Attachment to item number 5.1 -

Natural Values Assessment;
Wastewater Report;
Bushfire Assessment Report; and
Flood Hazard Report

Sorell Council

Development Application: Response to Request for
Information - 3 Gate Five Road, Carlton River - P6.pdf

Figure 1: Proposed subdivision at 3 Gate Five Road, Carlton.

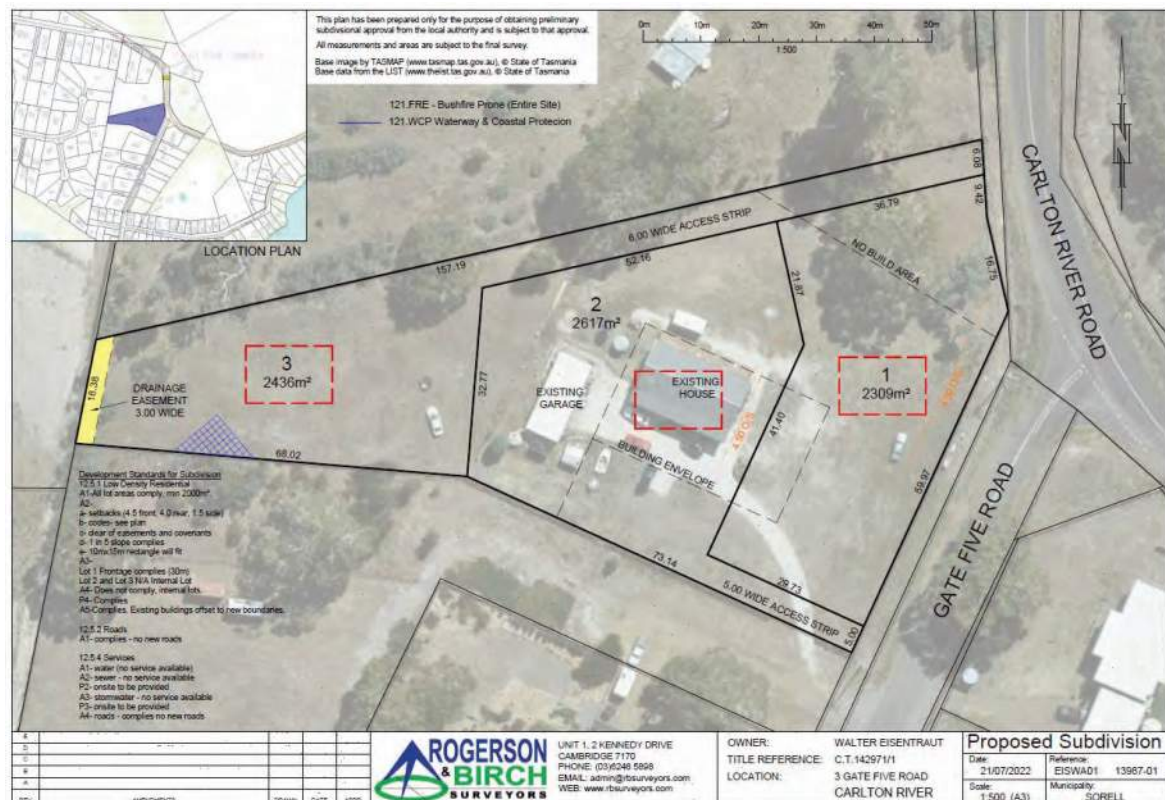
A request for further information (RFI) has been issued by the Sorell Council for a proposed subdivision at 3 Gate Five Road, Carlton¹. This report focuses on point 6 of the RFI, which requests a natural values assessment for the area of the proposed subdivision subject to the Waterways and Coastal Protection Code (the Code) under the *Sorell Interim Planning Scheme 2015*.

6. The property is subject to Code E11.0 Waterway & Coastal Protection Code of the *Sorell Interim Planning Scheme 2015*, therefore, please provide evidence by way of a Natural Values Assessment from a suitably qualified person to address any works associated with the subdivision in proximity to the waterway and any future development likely to be facilitated by subdivision is unlikely to lead to an unnecessary or unacceptable impact on natural values.

The study area is located at 3 Gate Five Road, Carlton (Figure 1). The proposed subdivision includes 3 lots. Lot 1 (2309 m²) has no existing infrastructure, with a small vegetated no build area at the northern end of the lot. Lot 2 (2617 m²) contains an existing house, with a fenced garden area and garage to the east. The remainder of the proposed area is lot 3 (2436 m²). This is the entire eastern extent of the property and comprises modified land with no developments present. Lot 3 is the primary focus of this report as this area is subject to the Code (see the blue diagonal lines in Figure 1).

Figure 9: Flood Hazard Summary Plan[CM5]

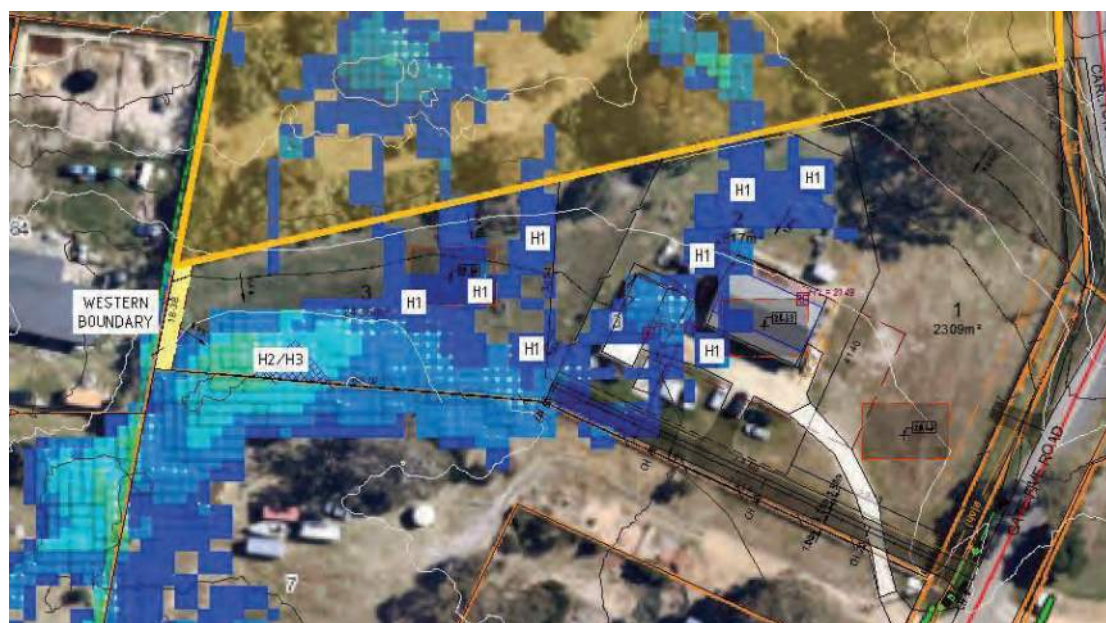
JMG Engineers & Planners have been engaged to undertake a Flood Hazard Report for the site (3 Gate Five Road - Carlton River) in order to respond to the Sorell Council RFI (SA 2022/4 - 1 3034425), topic 1 under the planning section.

In summary, as the vicinity of the building envelopes at Lot 2 & 3 presents slow vector velocities, even with high depths in the aforementioned area, the general classification of these areas are H1[JB3], being generally safe for people, vehicles and buildings - (relatively benign flow conditions / no vulnerability constraints[JB4]). Development of driveway and parking areas on the lots should be restricted to the non-hazard zones, or where necessary to access the building envelope, they should be restricted to the H1 hazard areas.

Lot 3 exhibits a deeper region approximately 30 metres away from the building envelope at its western boundary, with predicted depth levels reaching a maximum of 500mm. This depth margin increases the hazard risk to H2/H3, which should be cautiously avoided. Therefore, development of the Lot should avoid construction of driveways and outbuildings in this area so as there is no requirement for property owner to enter this zone during a flood event.

- The minimum finish floor level (FFL) for Lot 3 shall be 20.30m AHD to provide 300mm freeboard to the flood level.
- The building envelope should be out of the H2/H3 flood zone.
- In regions where H2/H3 hazard levels are, shall not have the presence of any building construction or carpark area.

DWG NO. C01 REVISION DA

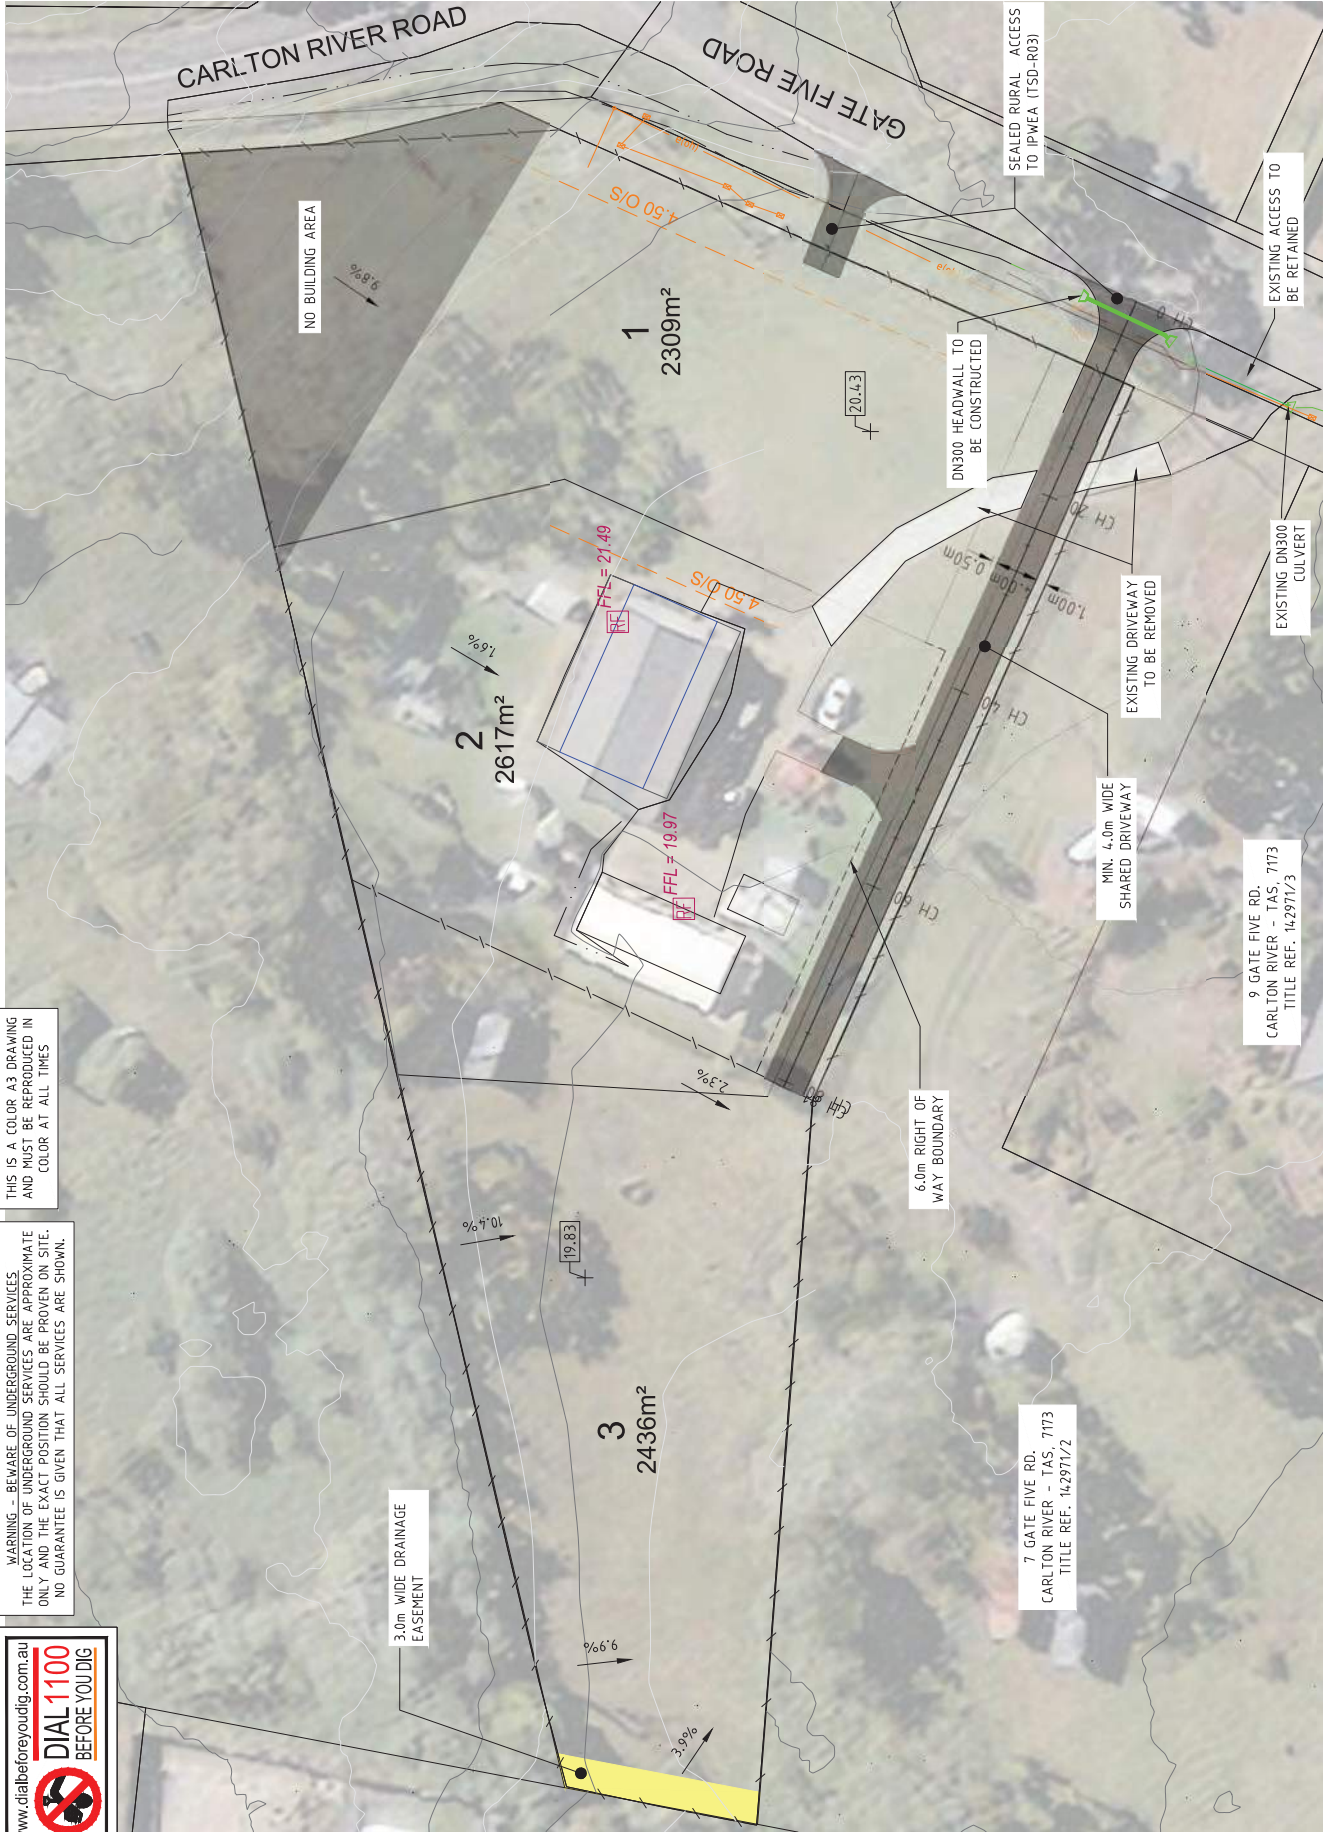
5. Provide some concept engineering drawings of each access, including details on the proposed dimensions, surface treatment, and drainage provisions for each access. Ensure any bushfire hazard management requirements are complied with. Additionally, include details/notation on the removal of the existing driveway.

5. Each access has been detailed with the proposed dimensions, surface treatment and the necessary drainage provisions in drawing (C01 - General Arrangement) attached with this letter response. Refer to Appendix 2.
